**TOWN OF SOUTH KINGSTOWN
OFFICE OF THE TOWN MANAGER
INTEROFFICE MEMORANDUM**

TO: THE HONORABLE TOWN COUNCIL
FROM: STEPHEN A. ALFRED, TOWN MANAGER
SUBJECT: MATUNUCK RELIC WALL RECONSTRUCTION AND THE TOWN'S PLANNED SHEET PILE WALL PROJECT
DATE: JULY 7, 2016

TO: Grover J. Fugate
DEPT: CRMC Executive Director
FROM: Danni Goulet, PE, David Reis, Tracy Silvia
DEPT: Combined Engineering and Biological Staff Review
RE: CRMC File No. 2015-11-007

Project: Demolish a dumped riprap seawall and reconstruct as a layered wall in a similar location with additional new stone brought in from off site.

Figure 3 Proposed Cross-Section of Town and Hang Ten maintenance application

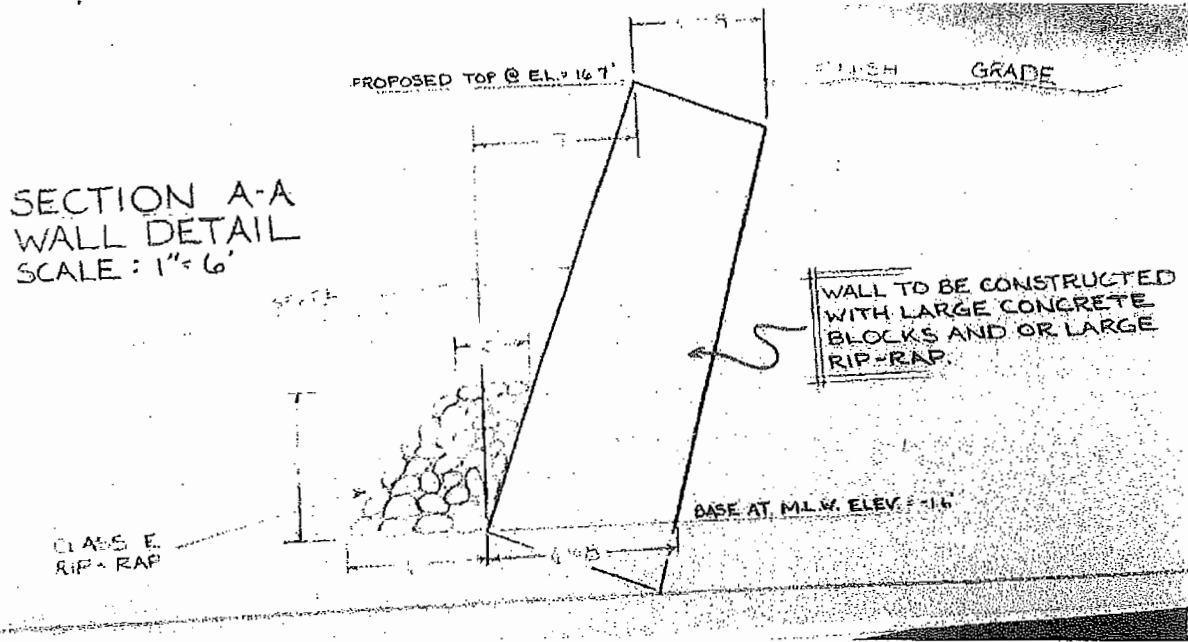
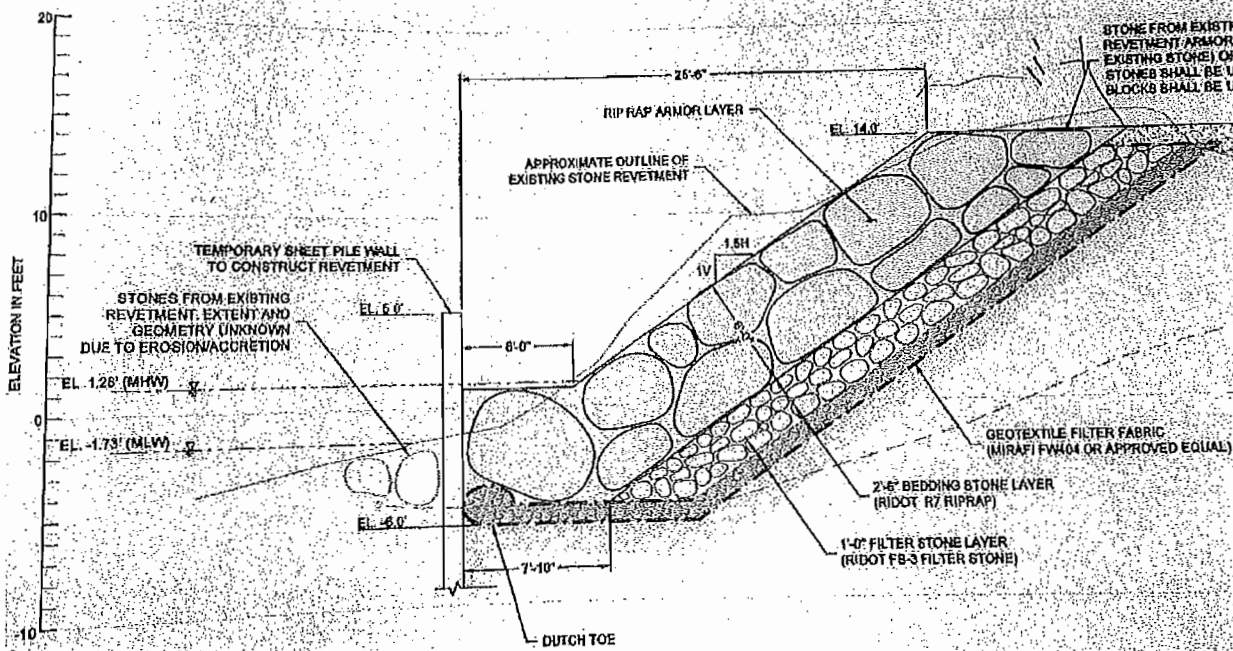
The approved cross section from the 1983 (Figure 2) plan and the proposed maintenance cross section (Figure 3) are provided below for comparison. What is hard to see in the 1983 cross section but shown in the plan view (provided by the applicant as part of the supplemental information) is the fact that when the 1983 wall was approved there was approximately 80 feet of beach in front of the wall. The approved 1983 wall was to have had the majority of the wall covered by sand as can be seen in the cross section by the line that shows the grade on the left side of the cross section.

Based on the definitions within the RICRMP that limit maintenance to *"Maintenance includes only those activities that do not significantly alter the assented design, purpose and size of the structure"* and *"shall be the minimum that is required to maintain the functional viability or structural integrity"* the current proposal

is in the opinion of staff beyond the scope of what can be considered as maintenance. A comparison of the engineering consultant's memo provided on behalf of the applicant in addition to the Council's Findings of Fact suggest limited maintenance of the previously authorized revetment would be acceptable. However a wholesale reconstruction, while it may be an appropriate engineering solution, appears to exceed the limits of what can be considered maintenance in this case.
